Subject: **Westbrook**

Federal Project No's: BH-1676(100)X &  
NH-1709(204)E

State PINs: 016761.00 & 017092.04

**Amendment No. 2**

LITTLE BRIDGE  
 MILL BROOK  
 WESTBROOK CUMBERLAND COUNTY  
**BOX CULVERT & WINGWALL DETAILS**

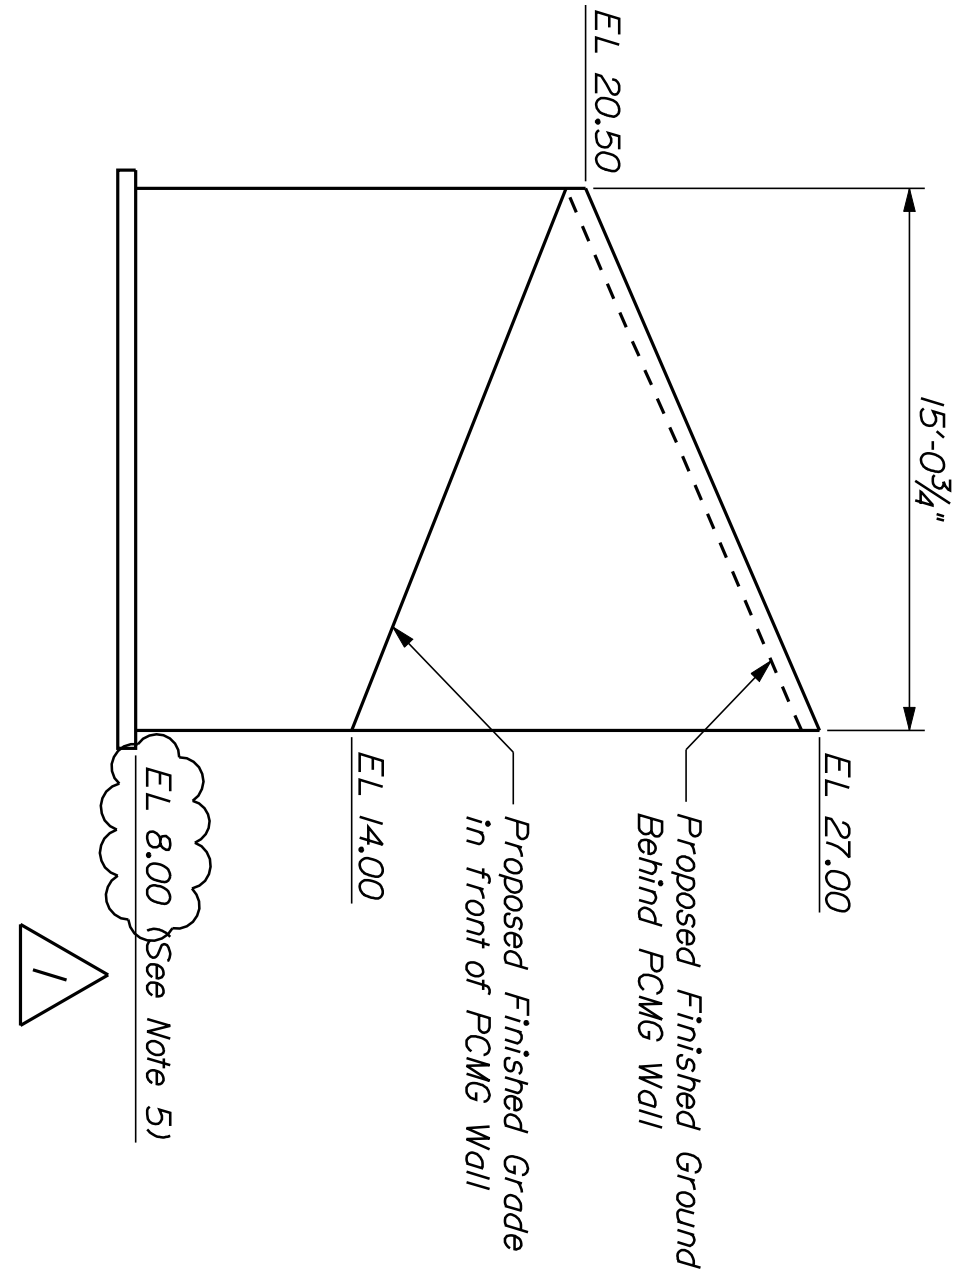
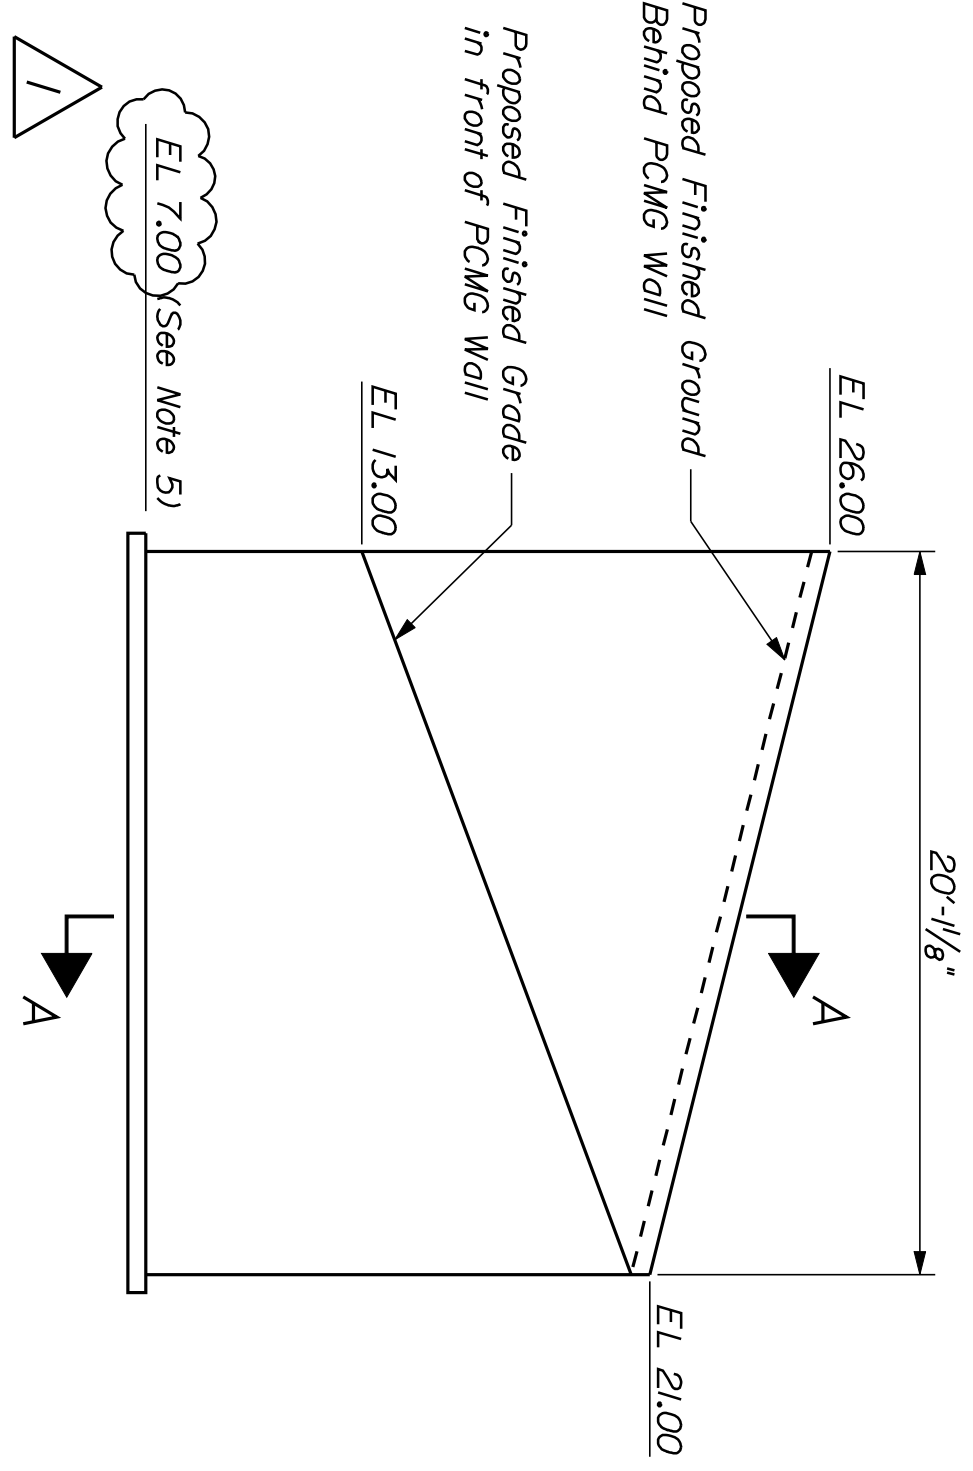
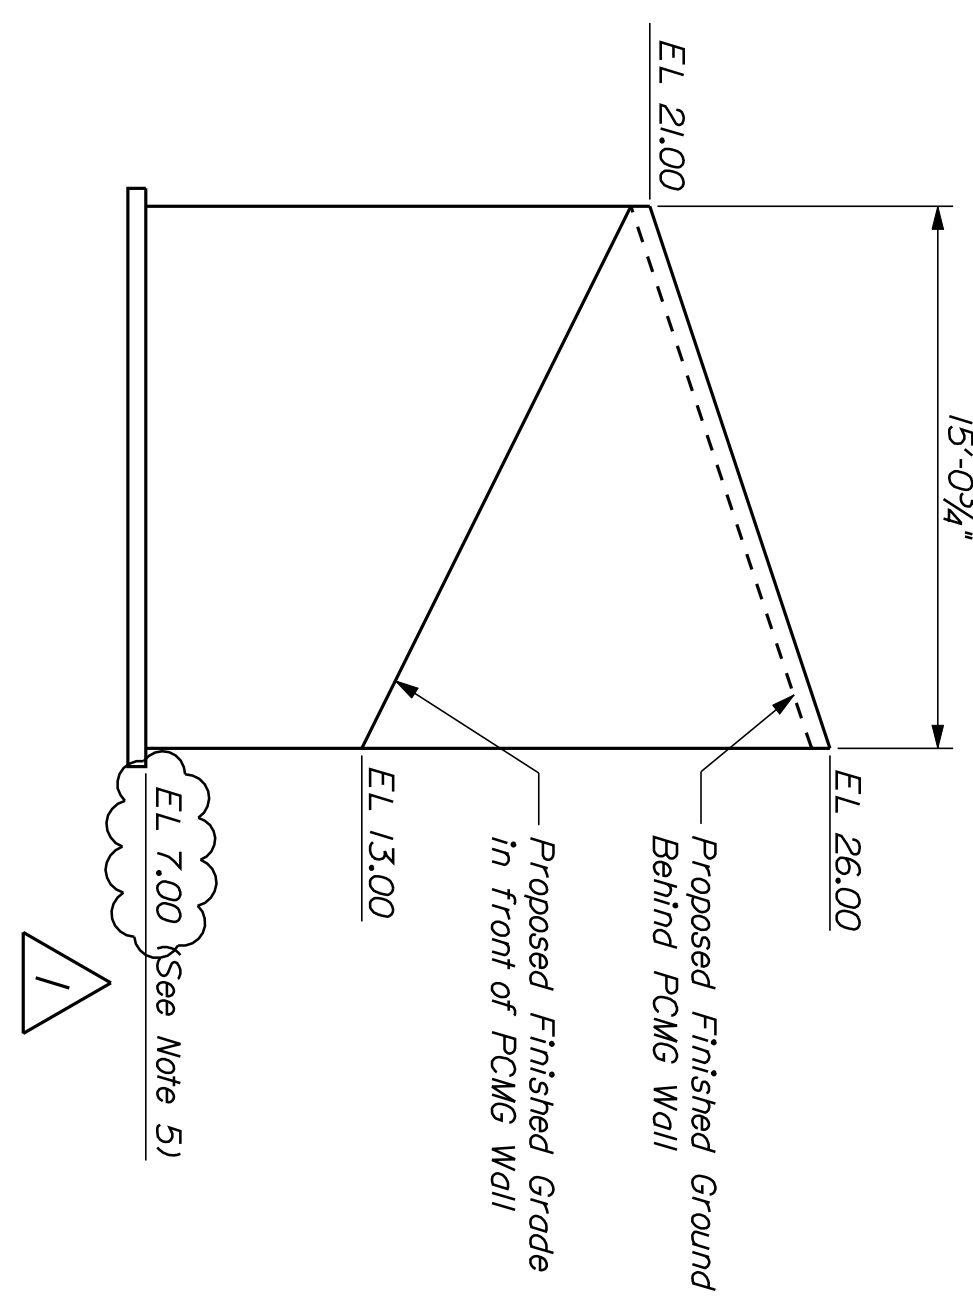
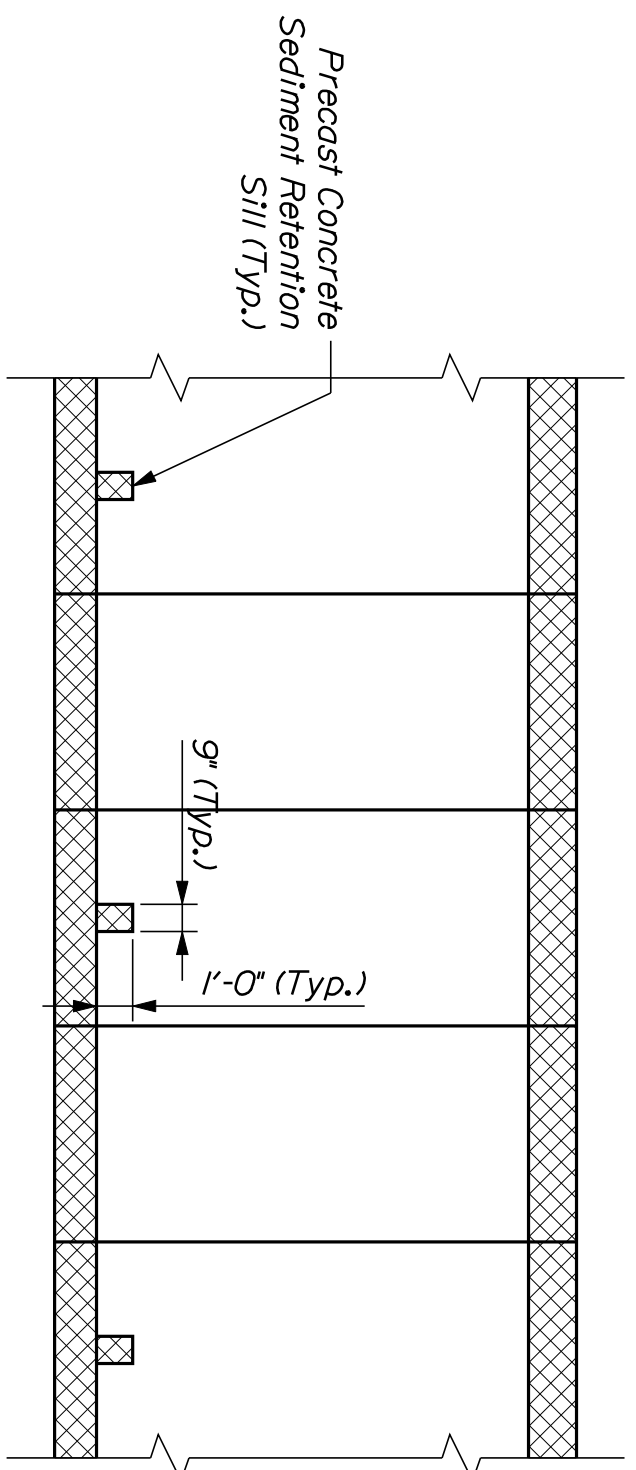
**Question:** The bottom of the wingwalls are six (6') feet below the invert of the box at Little Bridge. With this in mind shouldn't the toe wall on the box be deeper?

In the Plans, Little Bridge over Mill Brook (PIN 016761.00), **REMOVE** Sheet Number 12 of 14 and **REPLACE** with the attached new Sheet Number 12 of 14.

**Response:** The Wingwall elevations have all been raised and the Precast Concrete Toe Walls have new dimensions. Please see the changes to Sheet 12, Box Culvert & Winwall Details. Detail 1 also shows a dimension clarification to the Precast Concrete Headwall. The quantity for item 635.14 Prefabricated Concrete Modular Gravity Wall has been changed in the new Schedule of Items.
